MINUTES
BOARD OF BUILDING STANDARDS/
ARCHITECTURAL BOARD OF REVIEW/SIGN REVIEW

REVIEW MEETING
CITY OF LAKEWOOD
12650 DETROIT AVENUE
AUDITORIUM
October 8, 2026
5:30 P.M.

Docket No. 10-92-26 (1231 Lakeland)

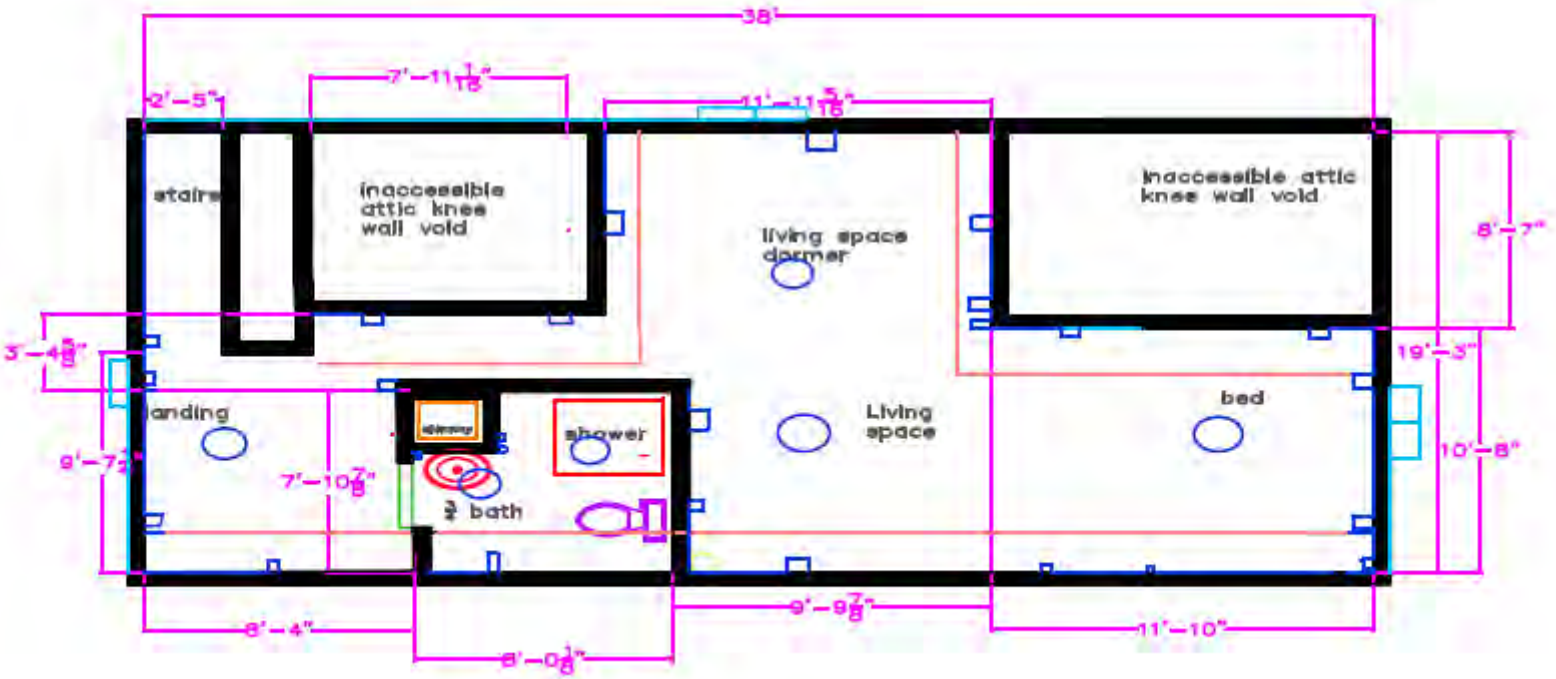
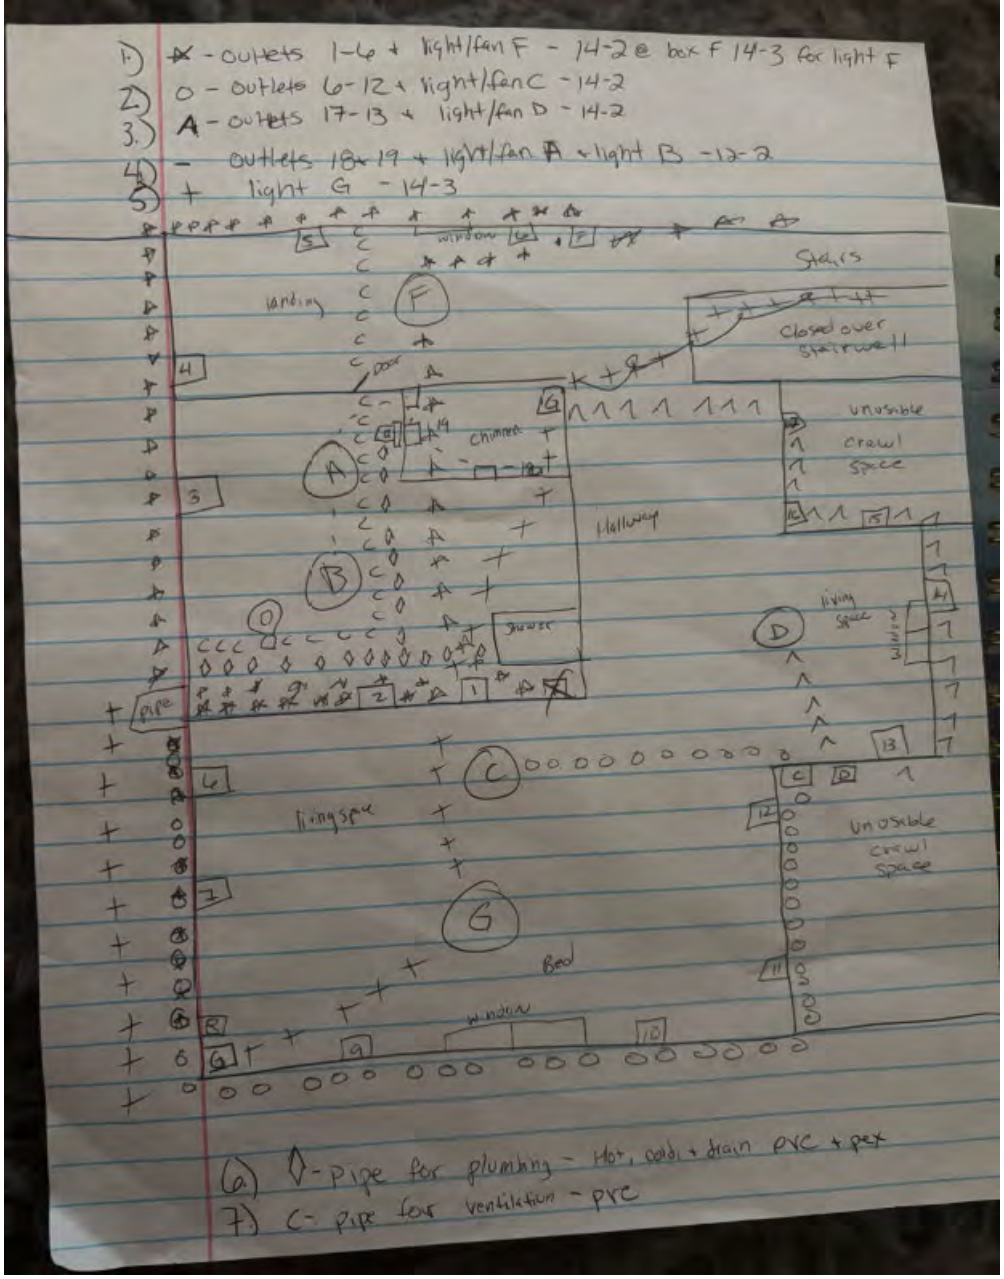
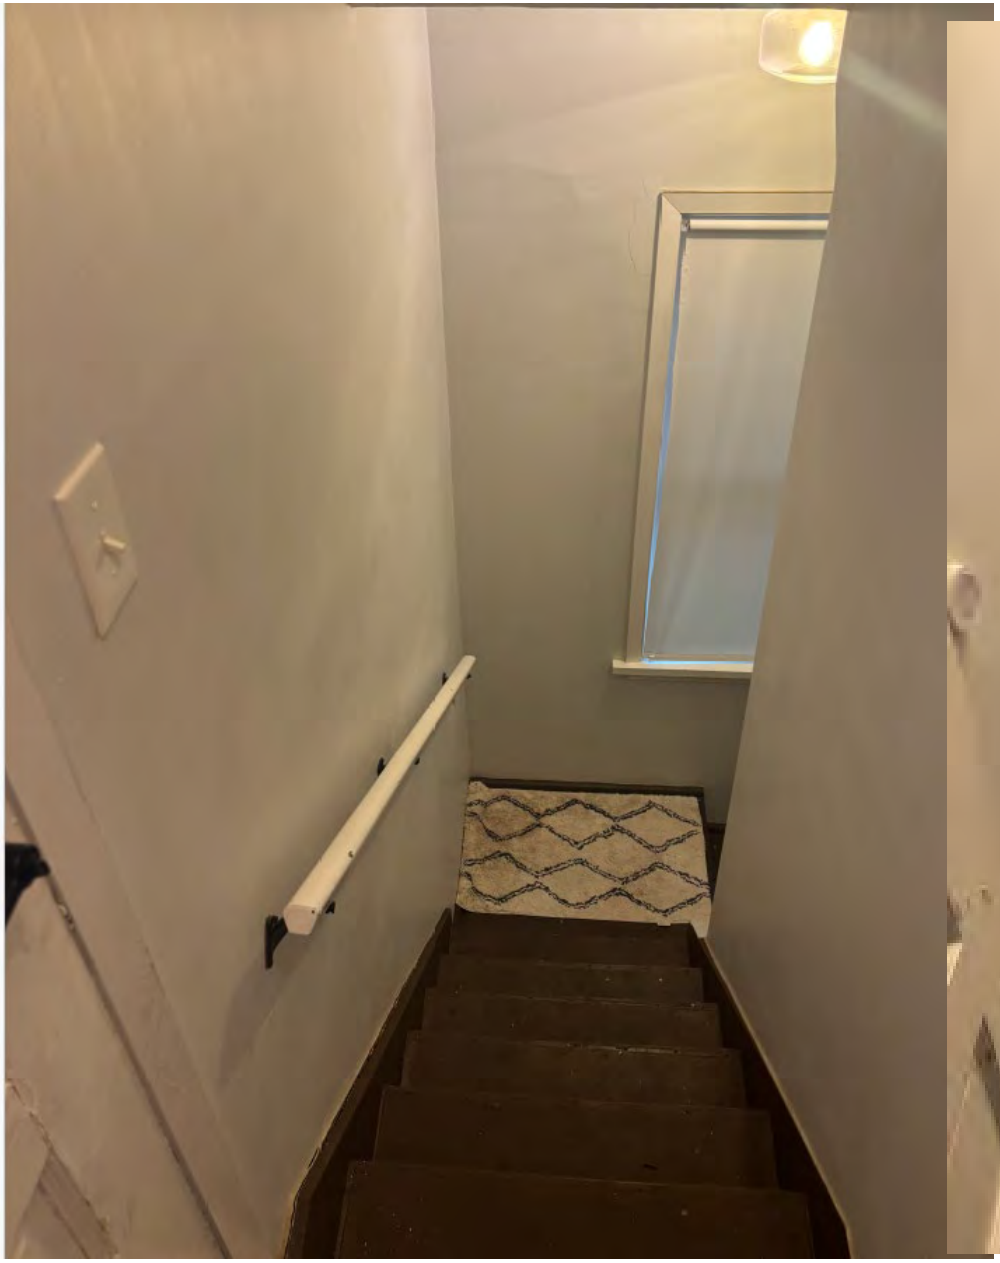
The proposed width for the existing stairwell is 29", 2 ½" less than the requirement of 31 ½" with one handrail installed on one side. The proposed use will change from an un-finished third floor to finished habitable area, not just storage. Important items to consider are the existing structure and the language inside RCO 113.4 *Additions or alterations to residential buildings shall conform with the requirements of the code for new construction and shall be approved by the residential building official. Additions or alterations shall not be made to an existing residential building or structure which will cause the existing residential building or structure to be in violation of any provisions of this code. Portions of the structure not altered and not affected by the alteration are not required to comply with the code requirements for a new structure.*

The reason 311.7.1 was called out on the plan review is the area will be used as living area, and the hazard of egress has changed. The area is no longer incidental unfinished storage. The Building Department, Residential Building Official, nor Building Official are granted authority to grant a variance on any state codes, that's why this matter is in front of the board. We have no say other than the existing staircase is not compliant with the intent of the code. However, I have provided a few takeaways to help you with your decision.

1) Manipulating the existing staircase could cause the alteration of existing bearing walls, impede egress paths elsewhere that were otherwise compliant, or be technically infeasible based on the construction method used during the original build.
2) If the variance was granted, additional safety measures could be conditions that the board would request for example, additional emergency escape and rescue openings in compliance with RCO 310.2.1, additional smoke alarms RCO 314, carbon monoxide alarms RCO 315 etc.

1) The window offers a secondary egress
2) Smoke Detectors/Carbon Monoxide Detectors will be installed

Docket No. 10-98-26 (14810 Detroit)

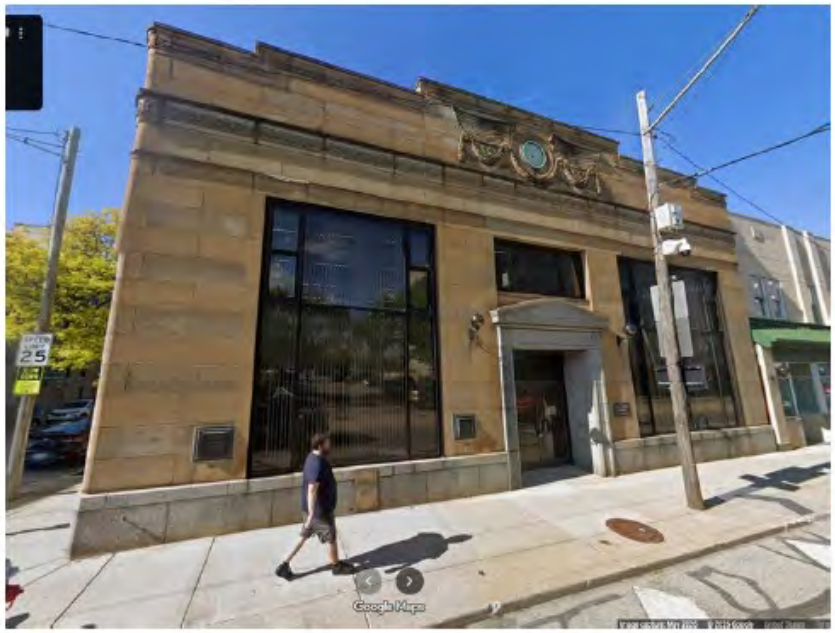
Painting, staining, or covering, such as but not limited to stucco, of previously unpainted or uncovered masonry surfaces is not supported or recommended. There are several reasons for the basis of this recommendation and generally include:

a. Painting masonry results in regular, costly maintenance whereas natural masonry is low in maintenance work and cost;
b. b. Painting masonry can result in moisture being trapped in the wall system causing unintended damage to the masonry itself and the building;
c. c. For historic buildings or those located in a historic district, painting of masonry is not recommended by the Secretary of Interior's Standards for Historic Rehabilitation and such action may result in the loss of the historic designation of the building or district – including possibly preventing a building or district from being nominated; and
d. d. There are other alternatives to the painting of masonry.

1) Second floor is inverted from what is shown today
2) Submit final paint samples (lighter than Iron Ore) to Board Secretary for administrative approval
